Access Compliance Report

Public Rights-of-Way

(Curb Ramps)

Intersection ID: 21456	Main Street: REGENT RIDGE LN	Cross Street: WITHERS MILL DR	Location:	N
ADA ID: 5ED6F368477B	Ramp Type: Directional1	Initial Pass/Fail: Fail	Overall Compliance: No	Severity Score: 25

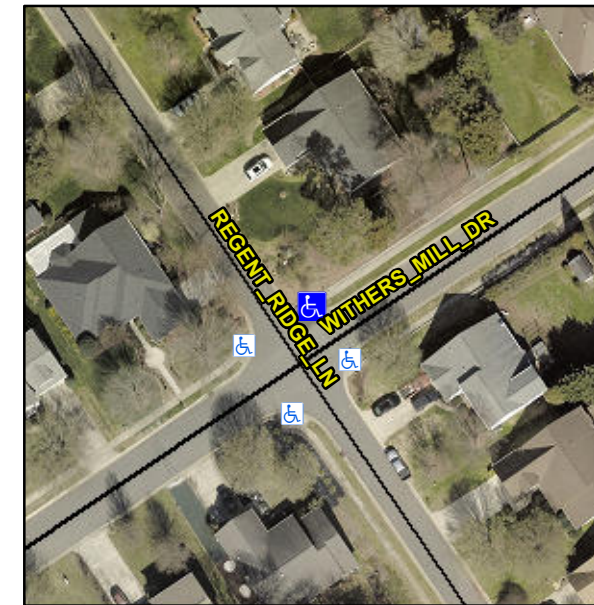
R304.5.3

Compliance	Description	Data	Compliance	Description	Data
N/A	Ramp Length (in)	48.0	N/A	Grade Break?	N/A
Yes	Ramp Width (in)	48.0	N/A	Grade Break Slope (%)	0.0
Yes	Ramp Slope (%)	0.2	N/A	Grade Break XSlope (%)	0.0
No	Ramp XSlope (%)	9.6			
N/A	Flare Type LT	N/A	N/A	Flare Type RT	N/A
N/A	Flare Slope LT (%)	N/A	N/A	Flare Slope RT (%)	0.0
N/A	Flare Traversable LT?	N/A	N/A	Flare Traversable RT?	N/A
N/A	Landing Length (in)	0.0	N/A	DWS Provided?	N/A
N/A	Landing Width (in)	0.0	N/A	DWS Contrast?	N/A
N/A	Landing Slope (%)	0.0	N/A	DWS Length (in)	N/A
N/A	Landing X Slope (%)	0.0	N/A	DWS Full Width?	N/A
N/A	Landing Curb? (Y/N)	N/A	N/A	DWS Offset LT (in)	N/A
N/A	Shared Landing?	N/A	N/A	DWS Offset RT (in)	N/A
N/A	Gutter Ponding?	0.0	N/A	Gutter Slope (%)	N/A
N/A	Gutter Lip Ht (in)	0.0	N/A	Gutter X Slope (%)	N/A
N/A	Painted X Walk1?	No		Road Slope (%)	5.1
	X Walk 1 Direction	To SW		Road X Slope (%)	3.4
	X Walk 1 Width (in)	N/A		Clear Space?	N/A

Possible Solutions:

Remove & Replace Entire Ramp.
